**ANSWERS FOR QUESTIONS ASKED BY NATURAL RESOURCES CANADA**

FOLLOWING THE REVIEW OF JOURNEAUX ASSOC PERMAFROST REPORT FOR HOWSE DEPOSIT

**Figure 1: Location plan showing Golder Associates borehole HW-GT13-01 equipped with thermistor**

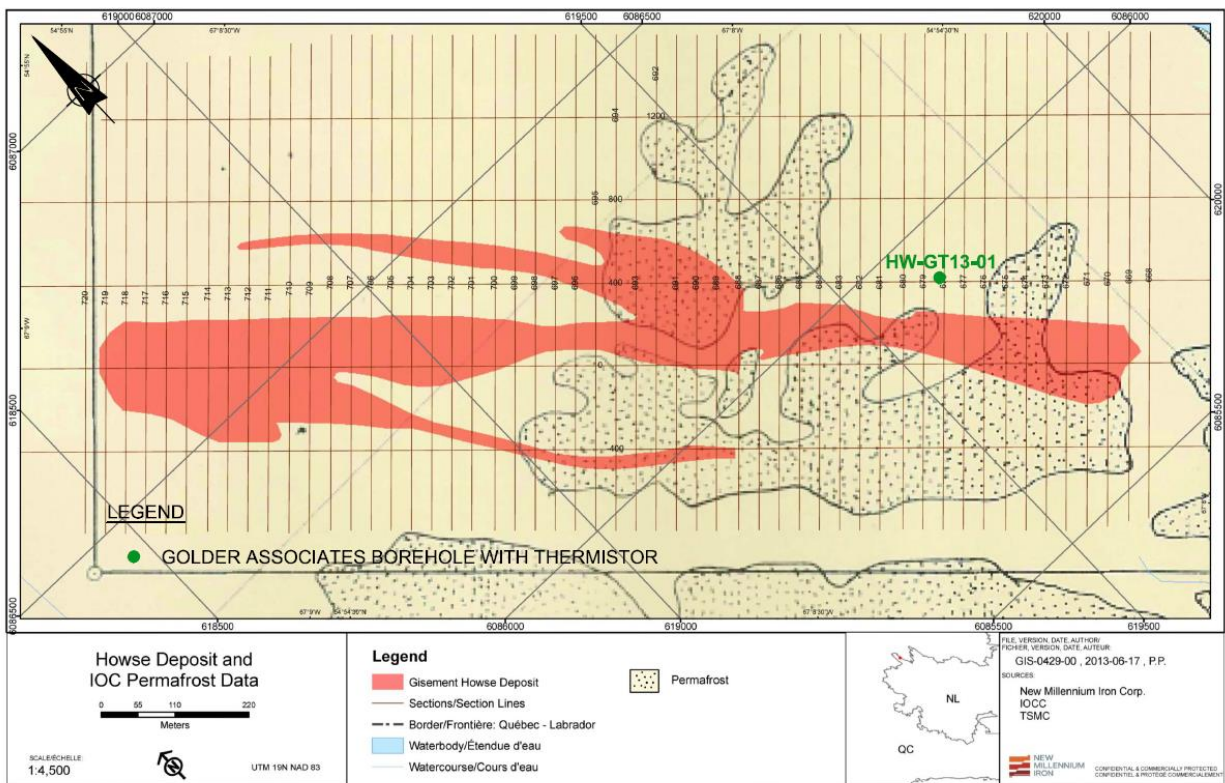
**NRCan Request:** Please confirm that the borehole HW-GT13-01 equipped with a thermistor cable as reported by Golder Associates (Volume 2, Appendix A) is the same cable mentioned in the Report No. L-15-1802. If yes, please confirm the location of the borehole according to the “potential permafrost map” (Figures 6.19 and 6.20, Volume 1, Main Document).

The thermistor cable HW-GT13-01 mentioned in the Journeaux Assoc report L-15-1802 is the thermistor cable installed by Golder Associates in borehole HW-GT13-01 drilled in December 2013.

The borehole HW-GT13-01 is located at the south east limit of Howse deposit as shown below in Figure 1. As shown, HW-GT13-01 is between 50 m and 100 m outside the potential permafrost boundary limit shown on the plan prepared by IOC in the 1980s.

The permafrost boundary limit shown on the plan is a virtual line which does not exist in the field. When the drillers located the borehole on site, they intended to drill an inclined hole to intersect the east pit wall.

Figure 2: Ground temperature of McGill thermistor HW 1008 CC as reported by Granberg (1983)

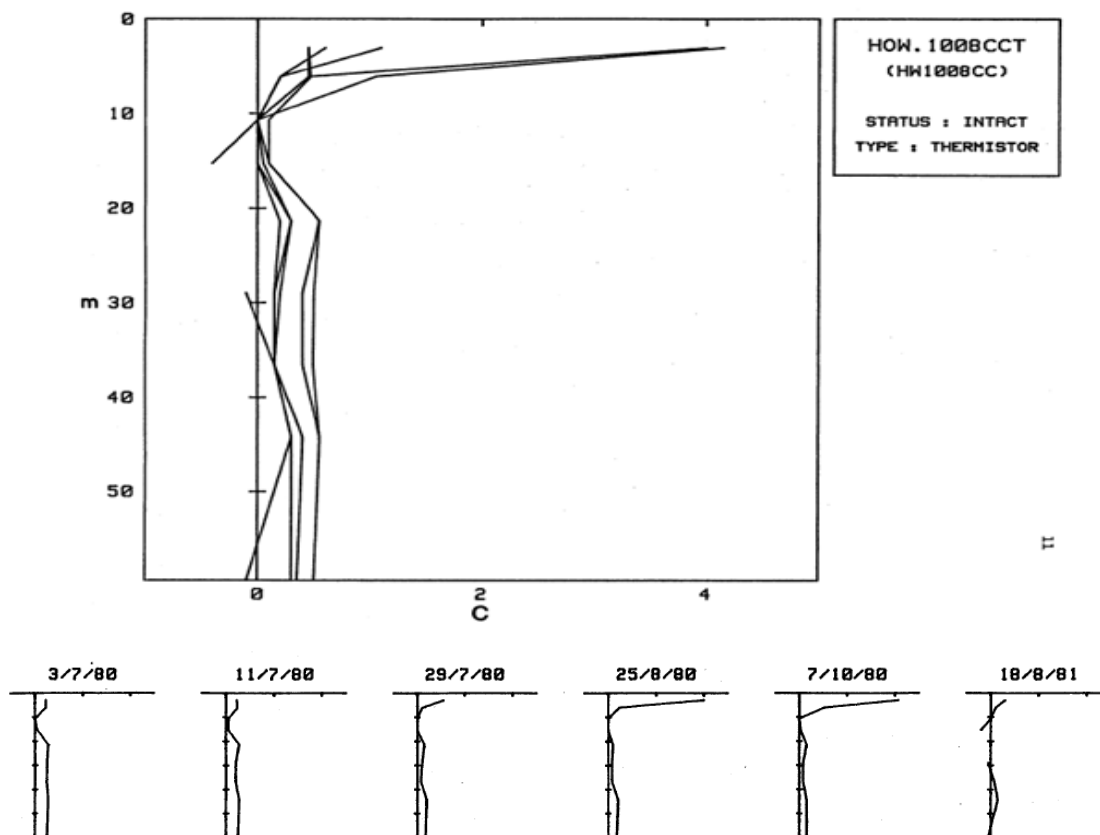
- **NRCAN request: Please provide clarification as to how this “potential permafrost map” has been produced.**

The ground temperature of the thermistor HW 1008 CC published by Granberg (1983) is presented in Figure 3. As it can be noticed the ground temperatures available from this thermistor are not very reliable due to the limited data collected. Thermistor HW 1008CC data shows in general no frozen ground with all temperatures above or around zero except in 18/8/81 a year later the surface ground temperature is still positive but much lower. This data shown in Figure 3 confirms that there is no frozen

ground at the middle of the permafrost map therefore this map is in error. Therefore the potential permafrost map presented or questioned by the NRCan does not reflect the present observations and data collected on site.
